RE: Percolation Test Results, 2026 Drover's Lane, A560622

RE: 2026 Drover's Lane, Percolation Certification Plan comments

Re: Vista Ridge Lot 8  
2026 Drovers Lane  
Revised Percolation Certification Plan

**VISTA RIDGE**  
LOTS 8  
2026 DROVERS LANE  
COOKVILLE, MD 21723  
LOCATION: TAX MAP No. 8 - GRID No. 23  
PARCEL No. 176  
4th ELECTION DISTRICT  
HOWARD COUNTY, MARYLAND  
TAX ID 04 595473  
TITLE: **REVISED PERCOLATION CERTIFICATION PLAN**  
DATE: JUNE, 2017 PROJECT NO. 2840  
SCALE: 1" = 50' DRAWING 1 OF 1

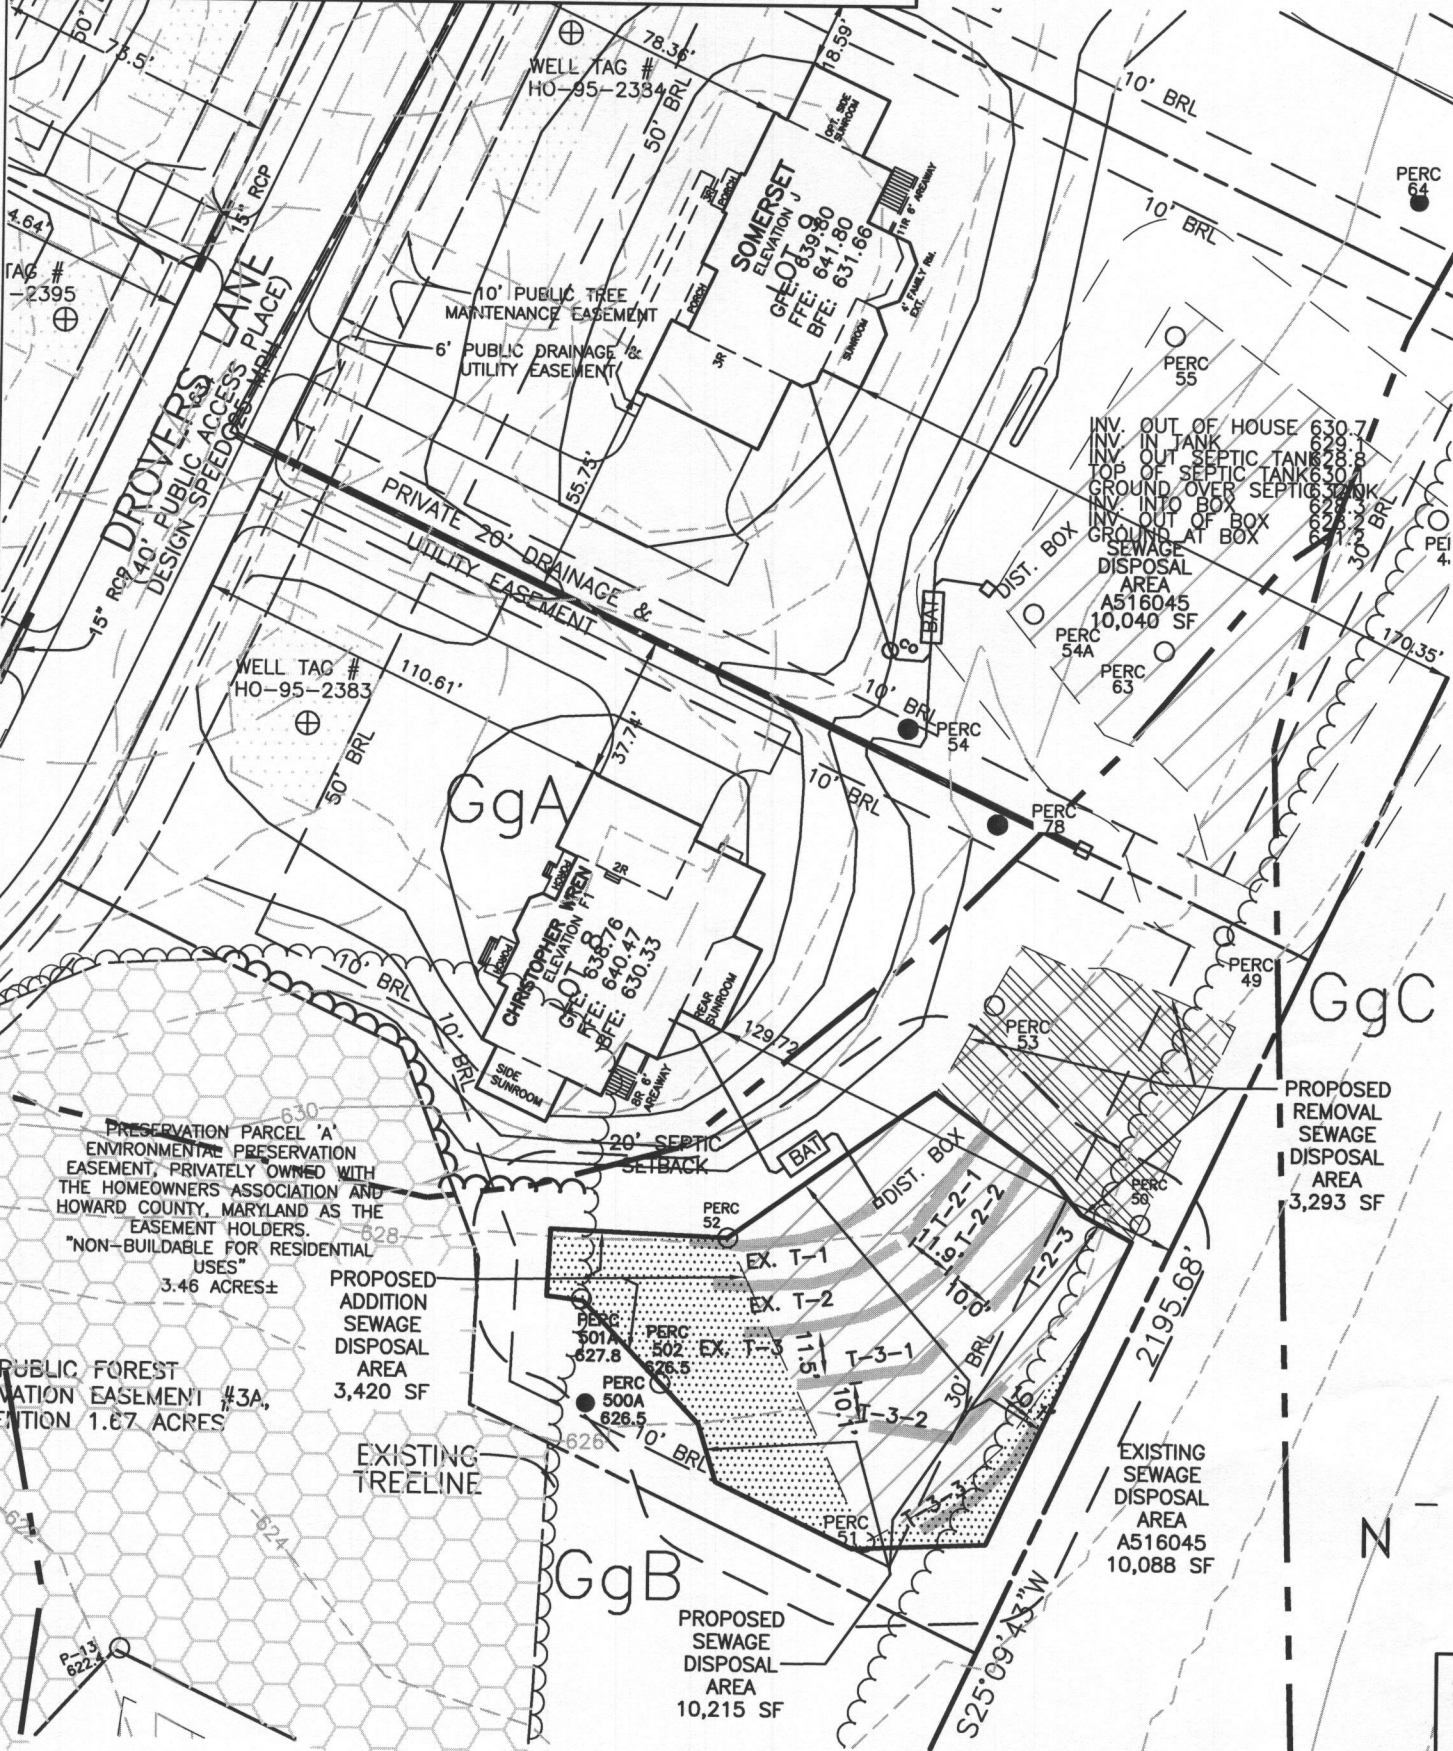
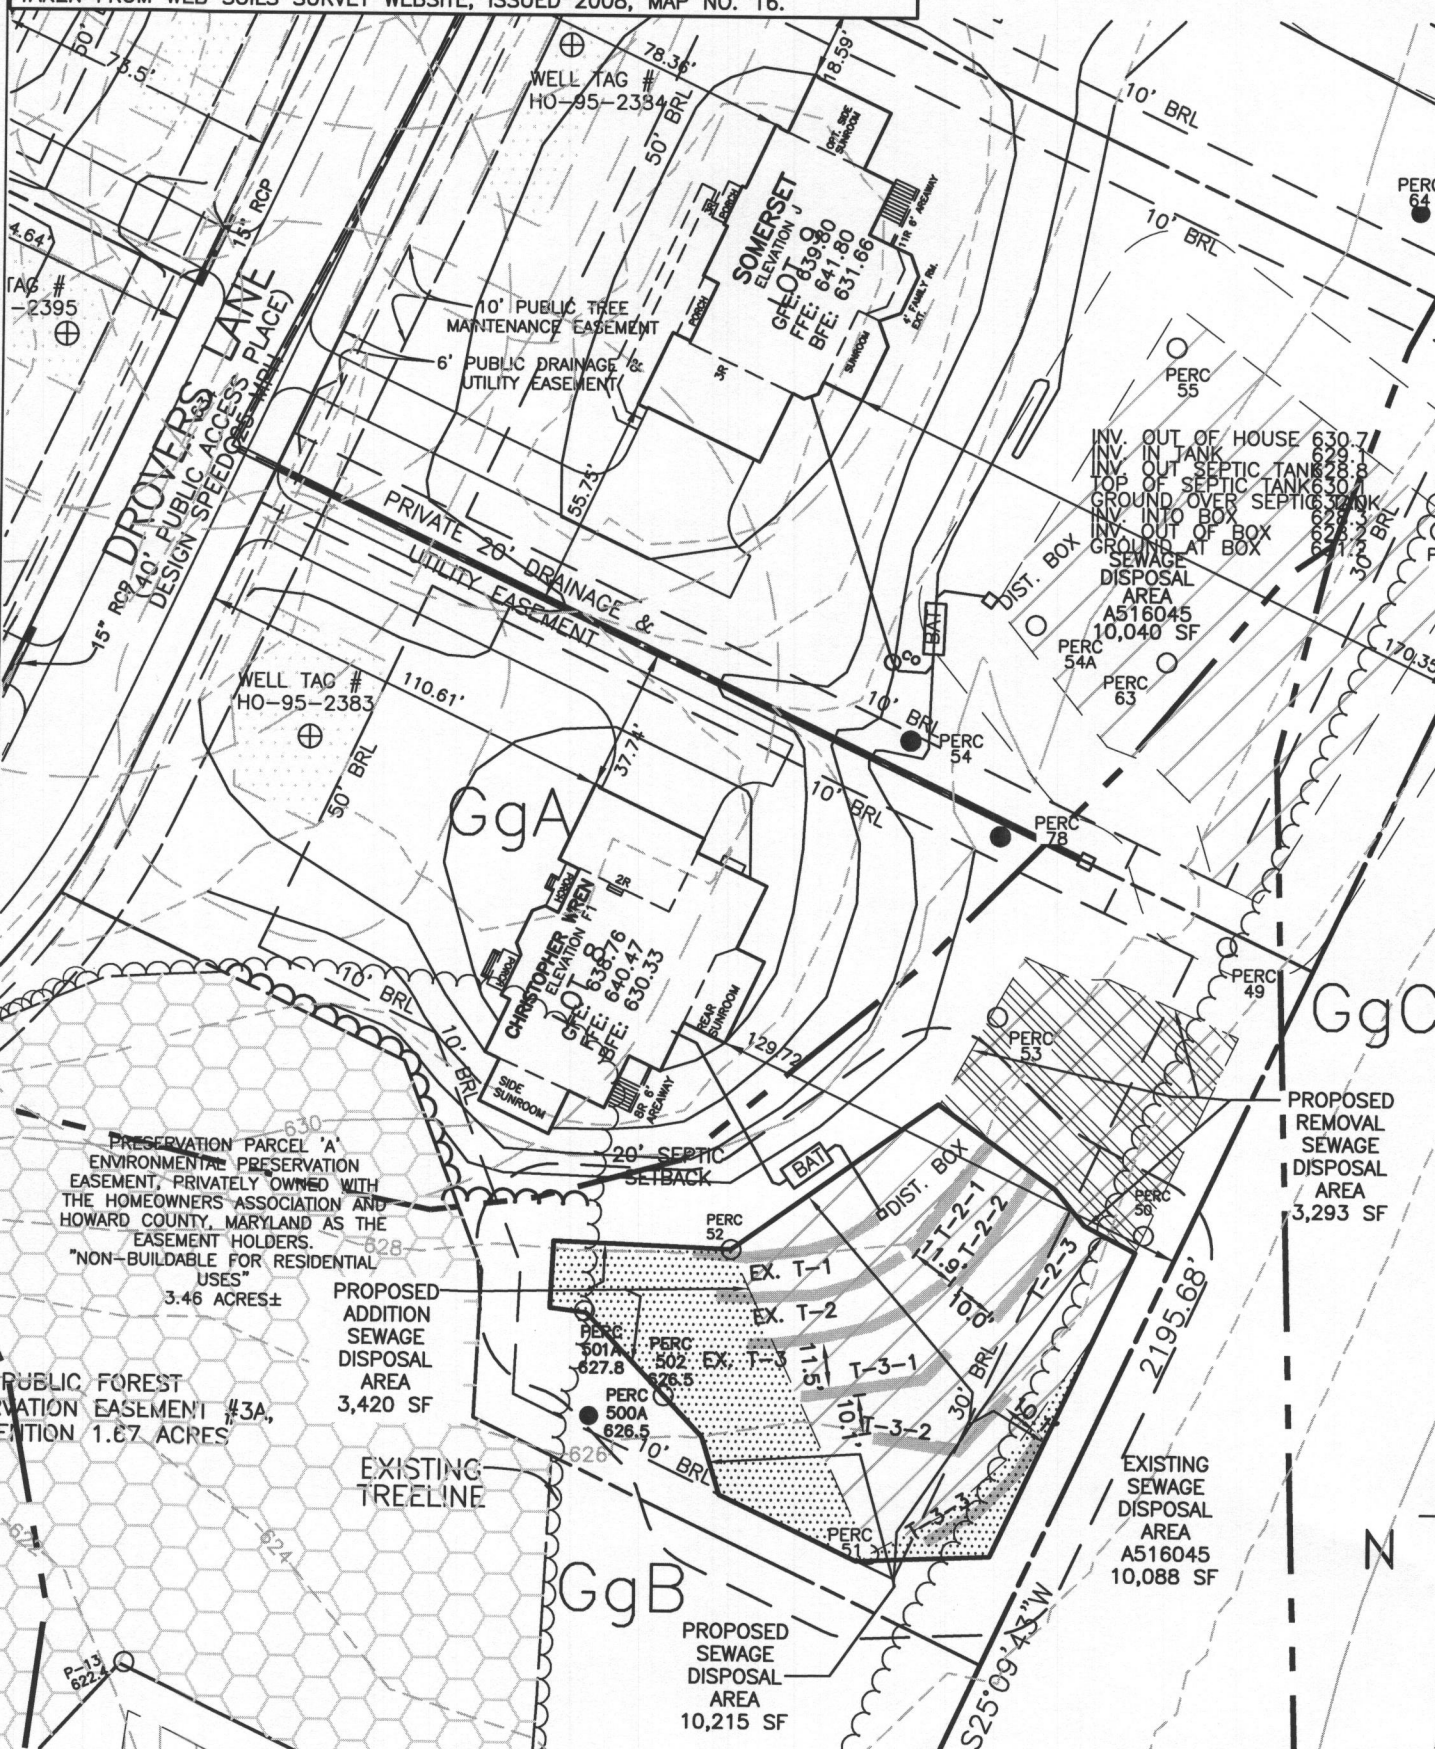
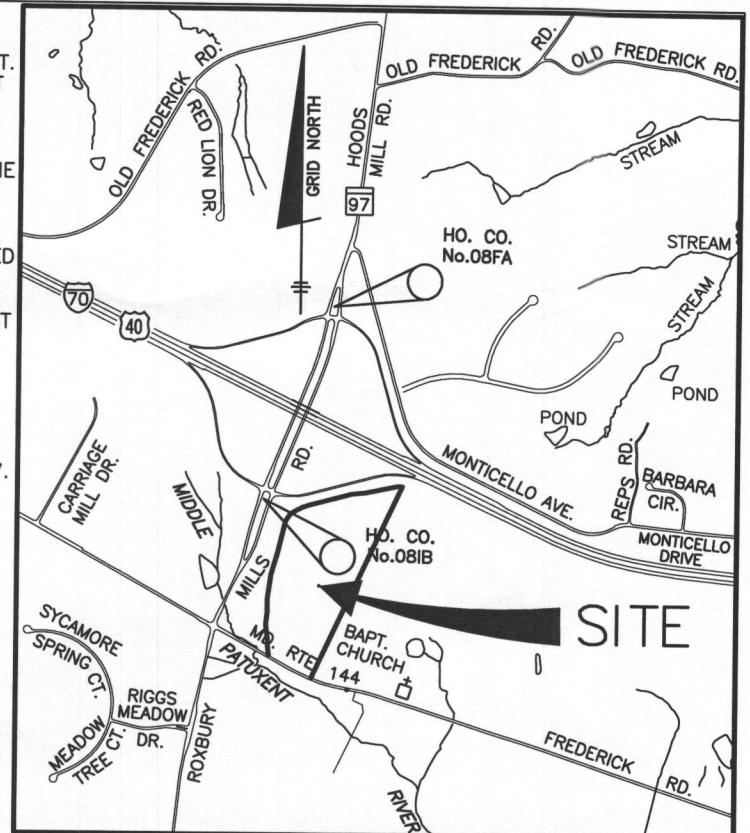
1. Delete Note 4.
2. The information in the SOILS LEGEND is outdated. Use the most recent soil map units (which are GgA and GgB) .
3. Illustrate the current soil map units on the subject property.
4. In LEGEND,
  - a. Edit several of the entries, replacing the term "SEPTIC" with 'SEWAGE'.
  - b. The structures on this plan area all existing; replace "PROPOSED" with 'EXISTING'.
5. Field-locate and illustrate the existing septic system components. The septic tank and the distal ends of trenches are easy to see.
6. In addition to the existing system trenches, illustrate the two replacement systems required by County Code. The replacement trench systems must be within the SDA, and the trenches must be spaced appropriately.
7. List the calculations for the replacement system trench lengths.

- 1.) General Note 4 has been deleted, the reference numbers for the other notes were updated as necessary.
- 2.) The soils legend has been updated.
- 3.) The current soil map units are shown in the plan view.
- 4.) The legend has been changed as requested.
- 5.) The existing trenches, tank and distribution box are shown per the detailed as-built and per aerial photographs that show the end caps and tank.
- 6.) The two replacement systems have now been shown on this percolation certification plan. The trenches remain in the Sewage Disposal Area and are and adequately spaced.
- 7.) The calculations for the replace systems has been shown.
